BAR Meeting
July 20, 2011

ISSUE: Partial Demolition/Encapsulation and Additions

LOCATION: 732 South Royal Street

BAR CASE #2011-0180 & 0181

Figure 4: Rear Elevation - Existing

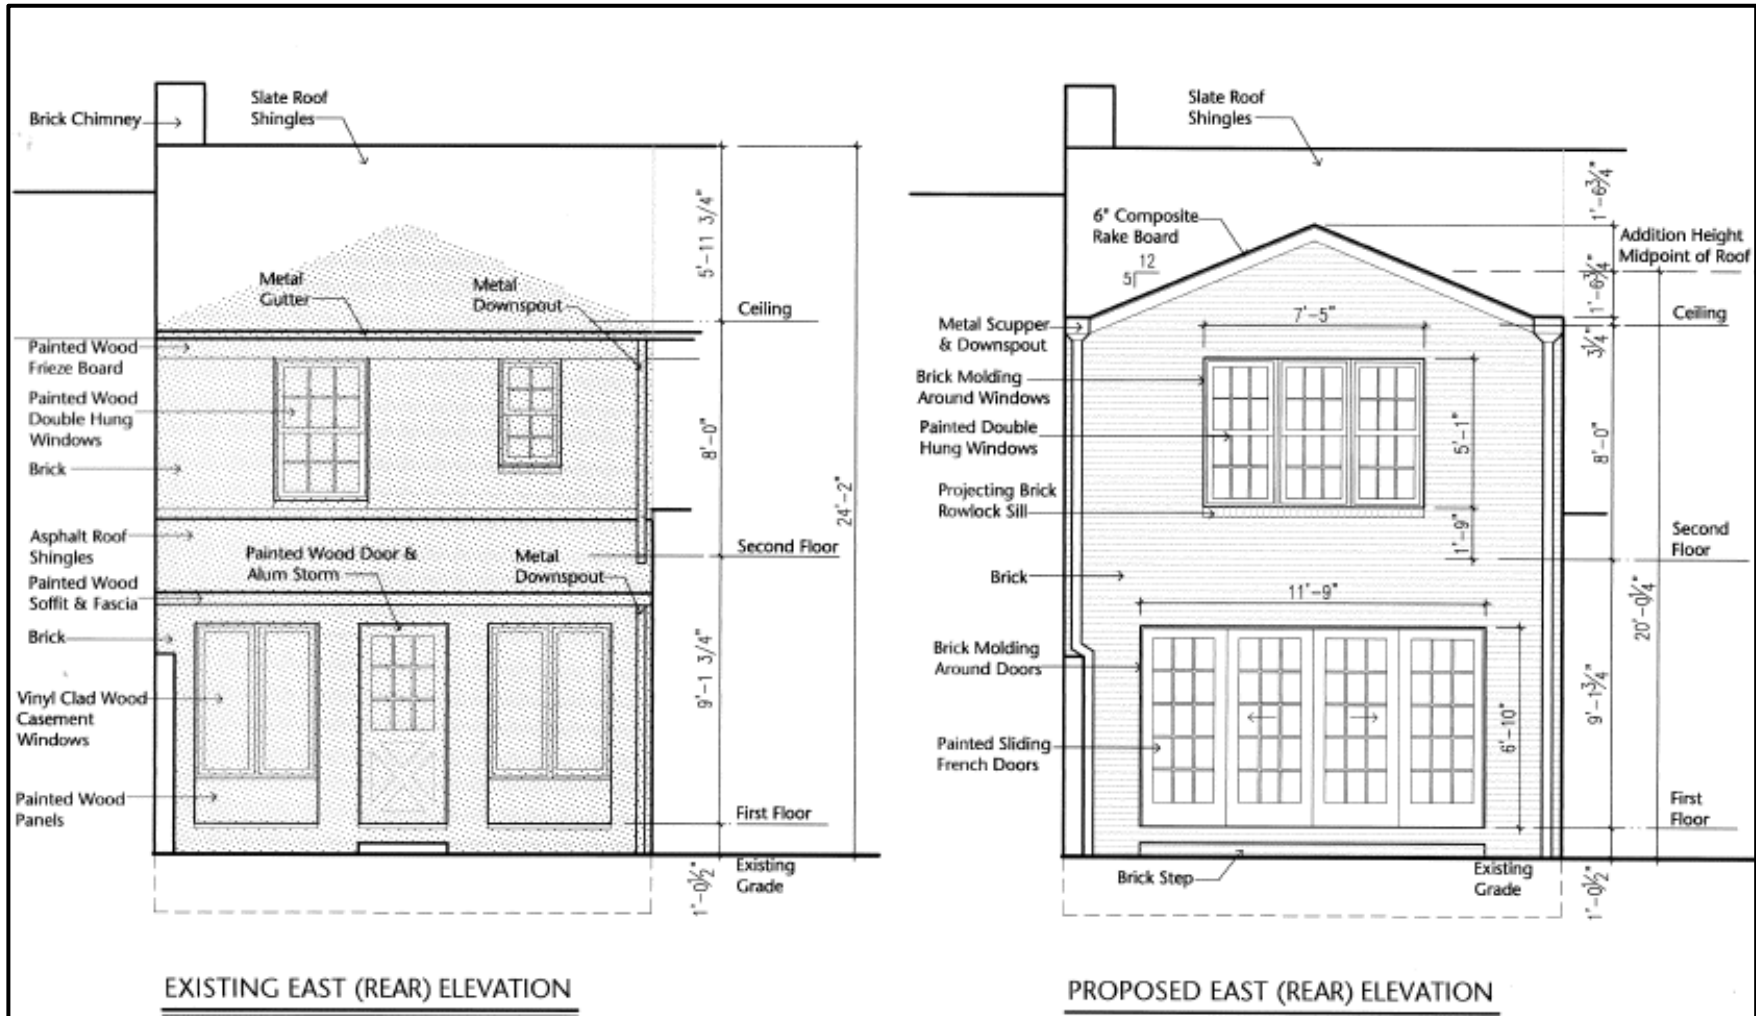
- Demolishing approximately 136 sq. ft. of exterior (east elevation) second floor wall surface of the original rear wall.
- Encapsulating the first floor of the c1947 one-story rear extension (approx. 153 sq. ft.)
- Removing the existing wood board fence in the rear yard along the north and east property lines.

The proposed rear addition will not be visible from South Royal Street. However, the second-story of the new addition will be visible from Jefferson Street. The second-story of the proposed addition is located on top of the existing (c1947) one-story addition and will require the removal of the original house’s rear second floor wall (approx. 136 sq. ft.) The resulting two-story, full-width ell will extend an additional 3.58’ beyond the existing footprint into the rear yard and encapsulate approximately 153 square feet of the existing (c1947) one-story addition. The new addition is being located on the rear, secondary elevation, and as such is respectful of the existing historic structure and does not negatively impact its integrity.

Figure 6: Existing South (Side) Elevation

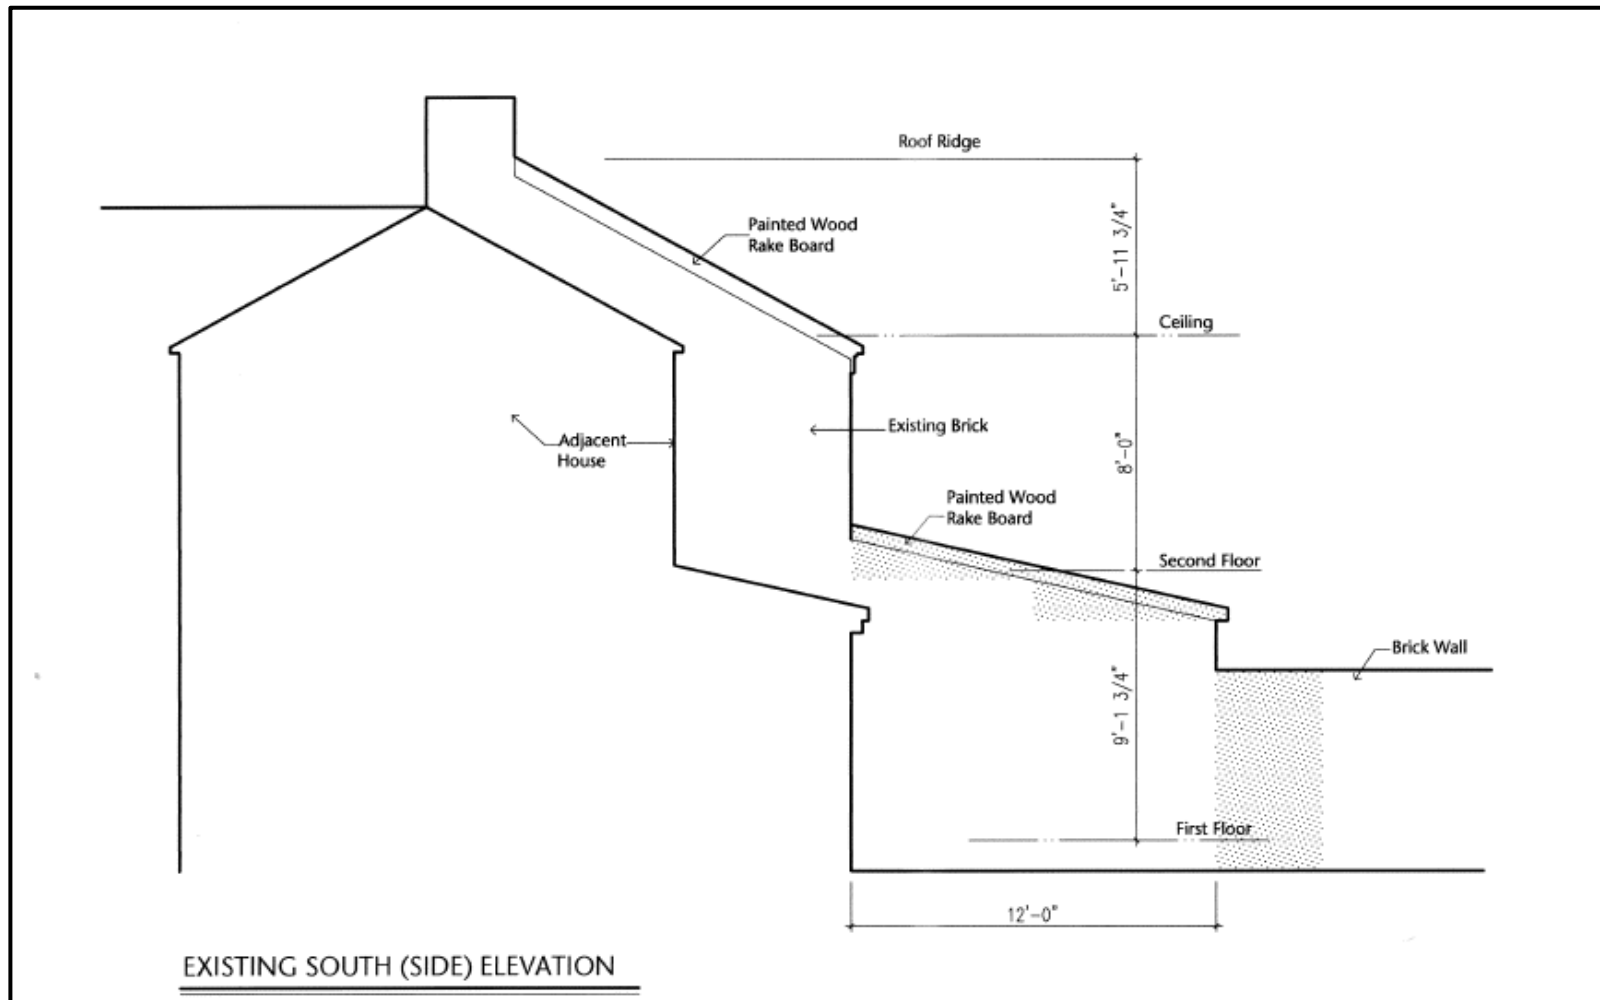
The proposed materials are appropriate for an addition and are compatible with the original building. The proposed doors and windows complement the original house’s light configuration and muntin width (6/6 windows, multi-light sliding doors and 5/8” muntins). However, vinyl-clad wood is not recommended in the BAR’s approved and adopted policies for windows and doors within the historic district. It is recommended that the material selection be modified to an aluminum-clad wood product. The proposed utilization of double-glazed, simulated divided light wood windows and doors on the new addition are in conformance with the Board’s policy. Additionally, the utilization of modern windows and doors, synthetic slate roof shingles, and a paintable composite fascia board provides the modern materials which subtly differentiate the historic body of the house and the new addition, as called for in the *Design Guidelines*.
